Re: Final Plat S/D 87-9 - HILLSIDE GARDENS 2ND ADDITION

At the regular meeting of the Subdivision Committee of the Metropolitan Area Planning Commission on Thursday, February 12, 1987, the above-captioned plat was considered. The action of the Committee was to recommend that this plat be approved subject to:

HILLSIDE GARDENS 2ND ADDITION TO ADDITION TO WICHITA, KANSAS

S/D No.: 87-9 Name: HILLSIDE GARDENS 2ND ADDITION

OFFICE COPY DO NOT REMOVE FINAL PLAT

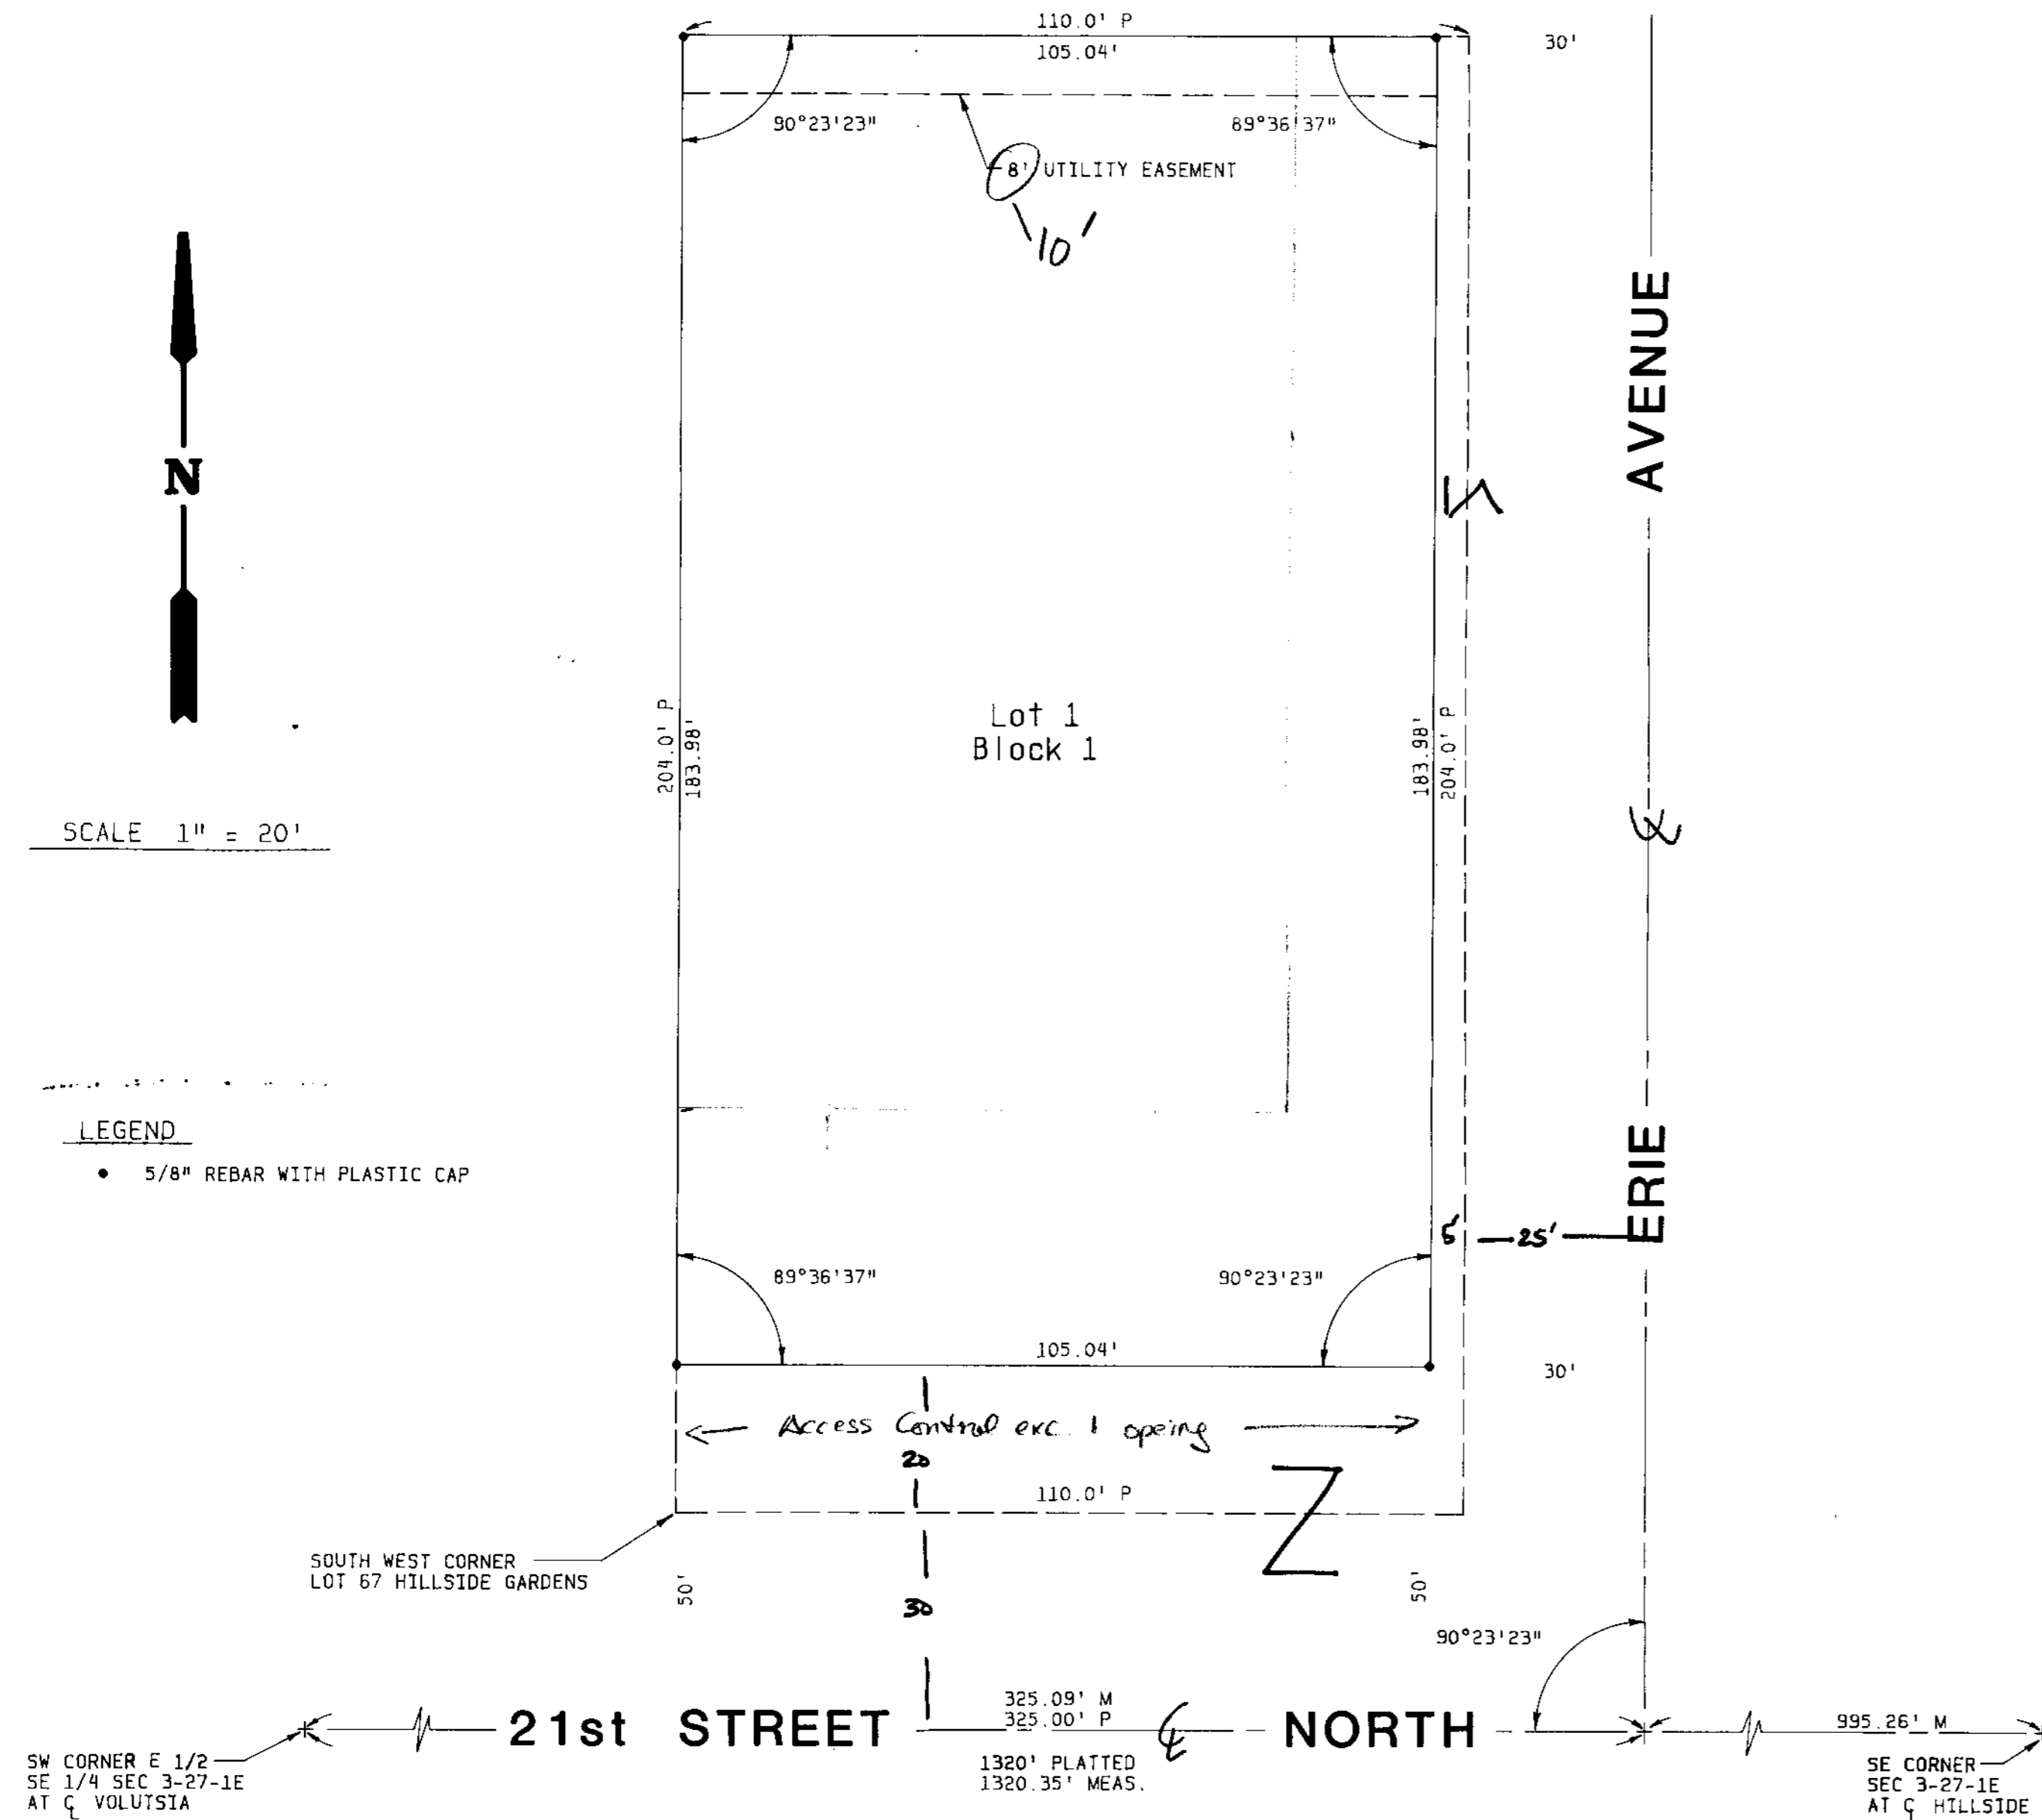
- ~~G.~~ The applicant's engineer is advised that the Register of Deeds is requiring the name(s) of the notary public, who acknowledges the signatures on this plat, to be printed beneath the notary's signature.
- ~~H.~~ The applicant shall install or guarantee the installation of all utilities and facilities which are applicable and described in Article 8 of the MAPC Subdivision Regulations.
- ~~I.~~ Perimeter closure computations shall be submitted with the final plat tracing. Section 5-101(C).
- ~~J.~~ Recording of the plat within 30 days after approval by the Board of City Commissioners.

- Needs*
- A. The final plat tracing shall indicate the platting of "access control except for one opening" to 21st Street North across the south line of this lot. The platting of this access control shall be referenced in the platlor's text. *Need to add phrase about permit to be determined by the City Engineer.*

- ~~B. The final plat shall indicate the amounts of half-street rights-of-way adjacent to the plat as well as the amount of additional rights-of-way being dedicated by this plat.~~

- ~~C. The final plat tracing shall label the centerlines of the adjacent perimeter streets.~~
 - ~~D. The final plat shall indicate a 10-foot utility easement adjacent to the north line of Lot 1, Block 1.~~

- ~~E. Since an existing sidewalk system does not exist to the north, it is recommended that the sidewalk required on Erie, by this lot's commercial zoning, be waived.~~

- ~~F. The final plat tracing shall indicate a 35-foot building setback from 21st Street North and a 20-foot wide building setback from Erie Avenue. Section 28.04.188.8 of the City's Zoning Ordinance provides for the construction of detached canopies within building setbacks.~~

- C. The final plat tracing shall indicate the platting of "access control except for one opening" to Hillside across the south line of this lot. The platting of this access control shall be referenced in the platting's text.

- D. The final plat shall indicate the amounts of half-street rights-of-way adjacent to the plat as well as the amount of additional rights-of-way being dedicated by this plat.

- E. The final plat tracing shall label the centerlines of the adjacent perimeter streets.
- F. The final plat shall indicate a 10-foot utility easement adjacent to the north line of Lot 1, Block 1.

- G. Since an existing sidewalk system does not exist to the north, it is recommended that the sidewalk required on Erie, by this lot's commercial zoning, be waived.

- H. The final plat tracing shall indicate a 35-foot building setback from 21st Street North and a 20-foot wide building setback from Erie Avenue.
- I. The applicant's engineer is advised that the Register of Deeds is requiring the name(s) of the notary public, who acknowledges the signatures on this plat, to be printed beneath the notary's signature.

- J. The applicant shall install or guarantee the installation of all utilities and facilities which are applicable and described in Article 8 of the MAPC Subdivision Regulations.

- K. Perimeter closure computations shall be submitted with the final plat tracing. Section 5-101(C).
- L. Recording of the plat within 30 days after approval by the Board of City Commissioners.

- M. The representative from the City Engineer's office should be prepared to comment on the status of the applicant's drainage plan. Specifically, are any drainage guarantees required with this replat?
